HISTORIC AND DESIGN REVIEW COMMISSION

October 03, 2018

HDRC CASE NO: 2018-491
ADDRESS: 1010 N HACKBERRY ST
LEGAL DESCRIPTION: NCB 521 BLK 16 LOT S 52.53 FT OF N 100 FT OF 11 ARB 11D
ZONING: IDZ, H
CITY COUNCIL DIST.: 2
DISTRICT: Dignowity Hill Historic District
APPLICANT: Cory Johnson
OWNER: Nicole Johnson
TYPE OF WORK: Rear addition, window and door replacement, fenestration changes.
APPLICATION RECEIVED: September 17, 2018
60-DAY REVIEW: November 16, 2018
REQUEST:

1010 N. Hackberry

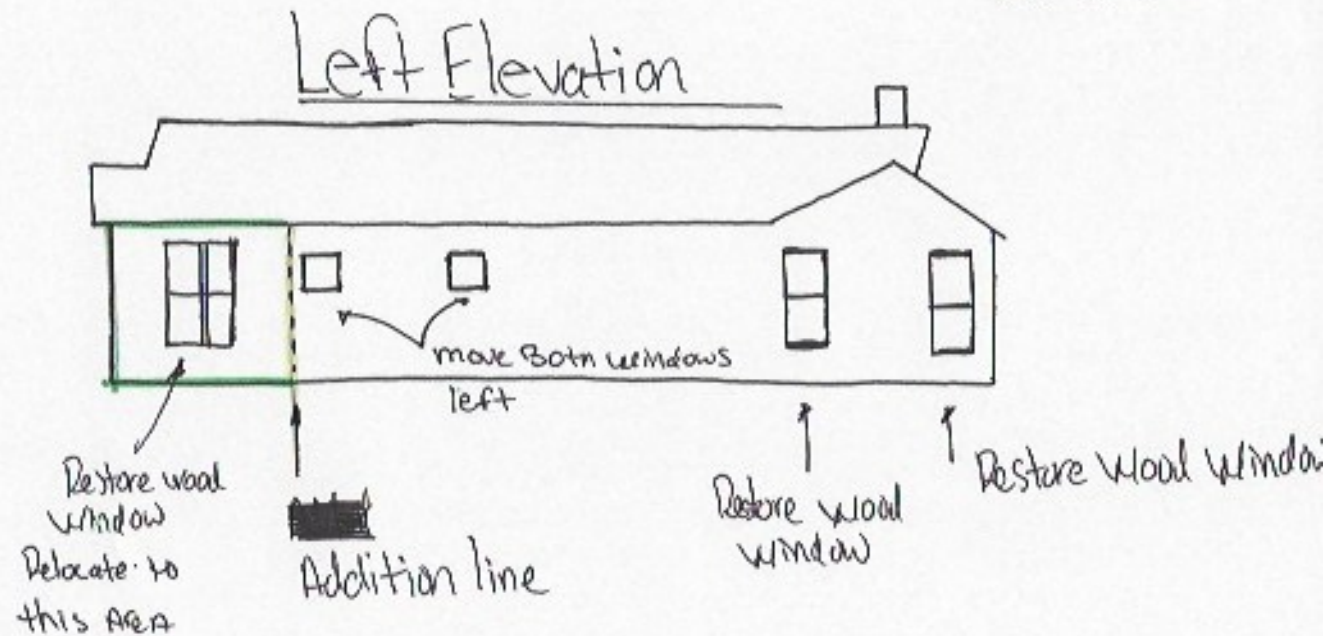
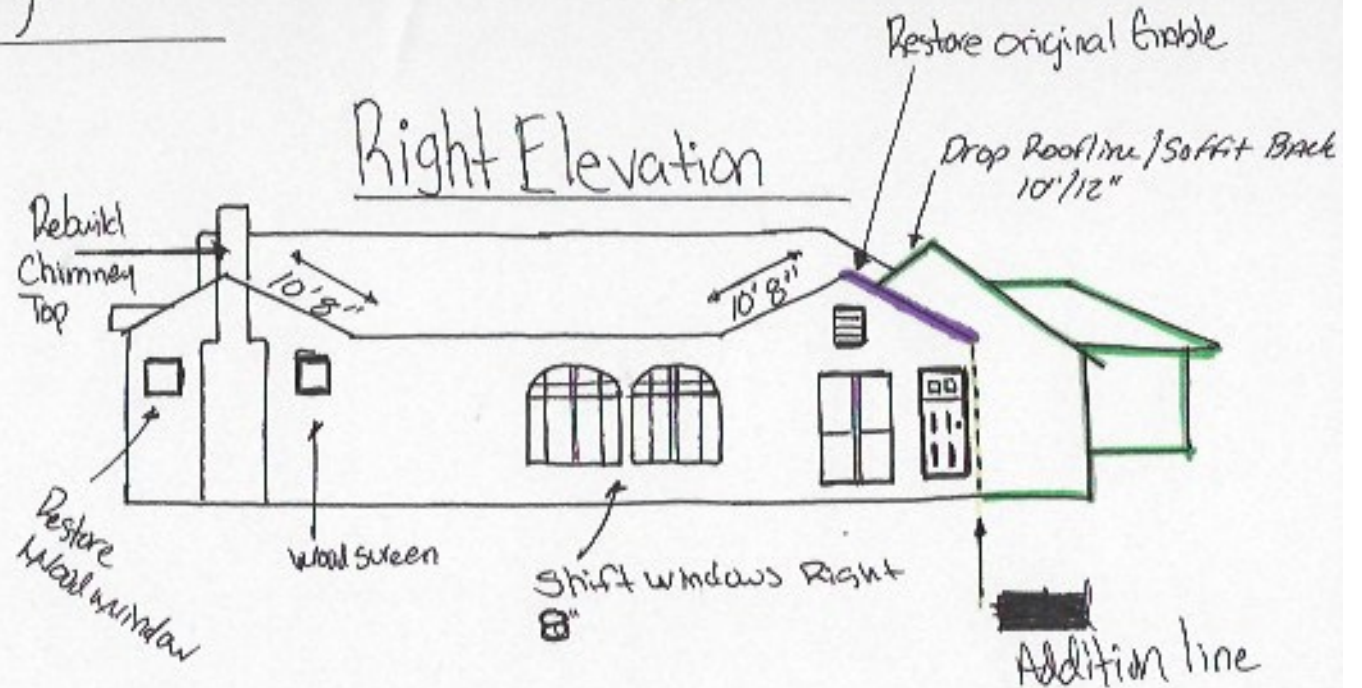
① Wood windows, Doors AND Screen Around Home

② Restore Original Rear Gable

③ Rebuild Damaged Chimney Top (Restucco)

④ Shift Architectural Window 8"

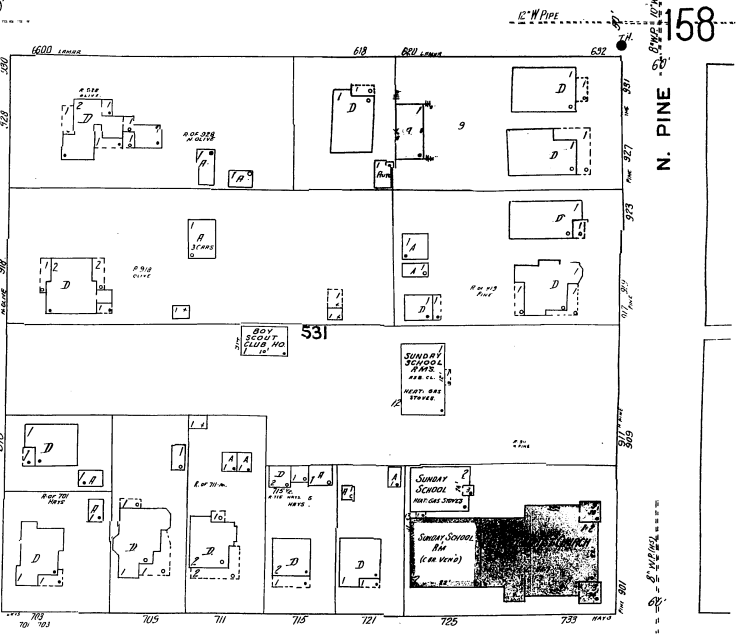
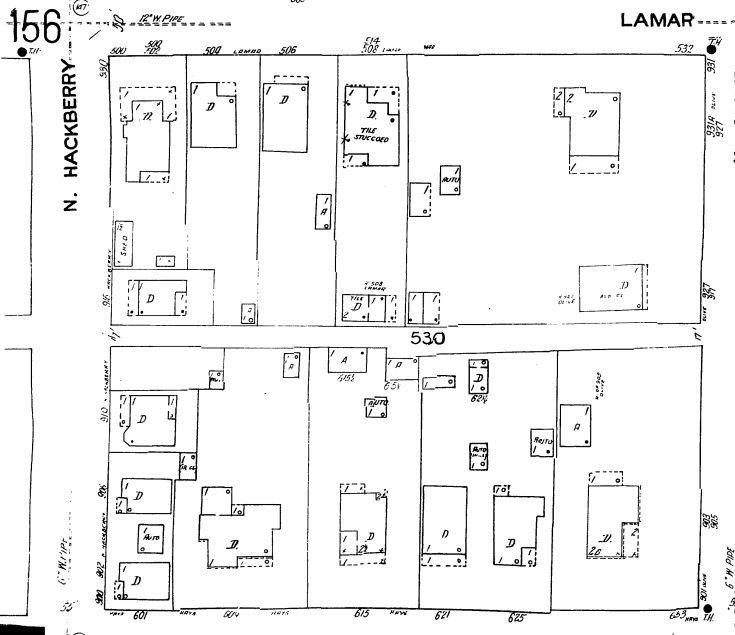
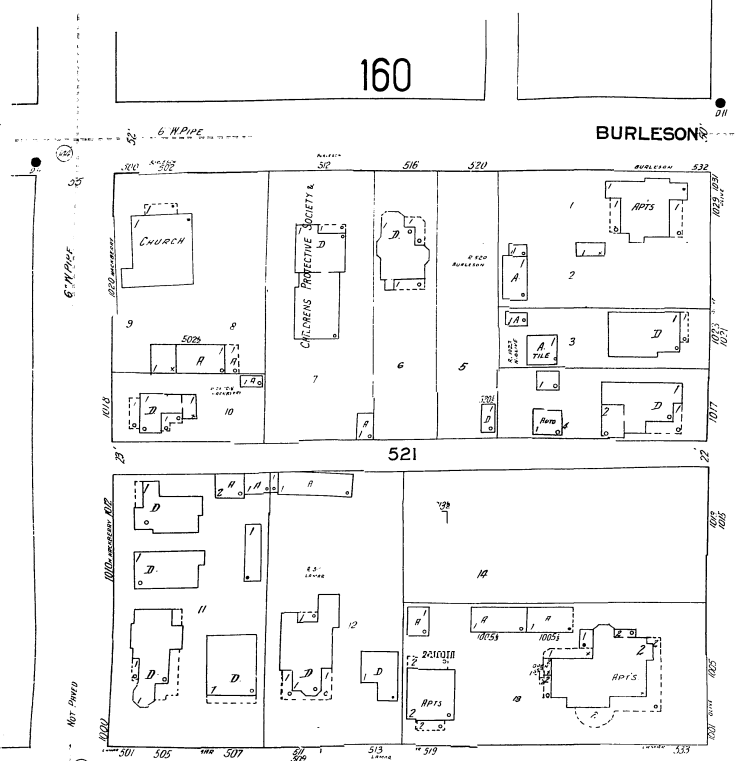
Addition line

Original Gable

Add'l Addition
